SERVICE BULLETIN

APPLICABILITY: 2012 and 2013MY Impreza
 2013MY XV Crosstrek™

NUMBER: 12-142-12

SUBJECT: Squeaking Sound from Front Seat Backrest

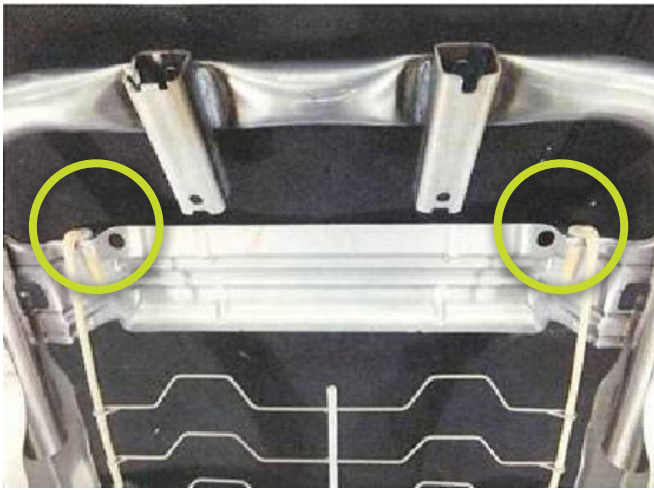
This Bulletin provides a repair procedure to address a customer concern of a squeaking-type sound coming from the driver or passenger front seat back. The flat mat main support rods are covered in paper to prevent metal-to-metal contact with the backrest frame. However, if an edge on the backrest frame damages the paper, metal-to-metal contact will result, creating the squeak. Bushings will need to be installed to prevent the condition. This procedure eliminates the need to replace the backrest frame.

The photo on the left shows the two locations where the sound originates, looking down from the top front of the backrest frame. The photo on the right shows one of the flat mat's main support rods (wrapped in paper) in position after the bushing installation procedure has been completed.

- Record customer's preset radio stations (and Navigation system favorites if applicable).
- Disconnect the negative (-) battery cable and wait at least 60 seconds before proceeding further.
- Remove the affected seat from the vehicle (refer to the applicable Service Manual).
- Remove the seat trim cover and cushion material as an assembly from the backrest.
- Remove the flat mat support rods from the top of the backrest frame, one side at a time.
- Install the bushings into the backrest frame as shown in the photos below. **NOTE:** putting the bushing in hot water (104° to 122° f) for a few minutes will ease their installation.

- After the bushings return to room temperature, confirm they are tight in the backrest frame and cannot be pushed out without using excess force (more than 5 to 6 lbs.).
- Reassemble the seat assembly.
- After reinstalling the seat, confirm the sound has been eliminated.
- Reconnect the negative (-) battery cable.
- Reset customer's preset radio stations (and Navigation system favorites if applicable).
